To: Mr Dean Gibson – Case Officer
Development Management
Bernard Weatherill House
8 Mint Walk
Croydon
CR0 1EA

From:
**Monks Orchard Residents' Association
(Planning)**

2nd August 2019

Reference:	19/03279/FUL
Application Received:	Fri 12 Jul 2019
Application Validated:	Fri 12 Jul 2019
Address:	Land R/O The Shirley Inn Public House 158 Wickham Road Croydon CR0 8BF
Proposal:	Erection of a residential development of two detached three storey buildings comprising a total of 6 flats (2x1bed, 2x2bed, 2x3bed), provision of refuse and cycle storage, hard and soft landscaping and provision of two parking spaces.
Status:	Awaiting decision
Case Officer:	Dean Gibson
Consultation Close:	Sun 11 Aug 2019
Target Decision Date:	Fri 06 Sep 2019

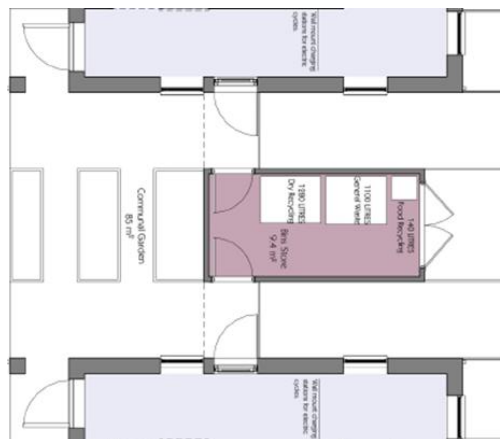
We object to this proposed development on grounds that the proposed development Bin Storage does not show **150mm clearance** between each Bin and the clearance from the front of each Bin requirement of 2m is not provided. This measurement is **1.1m** as measured on the supplied ground floor plan (at magnification 112% provides scale of 1cm = 1m). This fails the requirement of a clearance to the front of Bins of 2m within the Bin store.

There must be a minimum of **150mm clearance** around and between each bin within a storage area. Where there is more than one bin within a storage area, there must be **2m clearance in front of each bin** to enable it to be accessed and safely moved without needing to move any of the other containers.

All doors and alleys must be at least **2m wide** to allow for safe manoeuvring of bins.
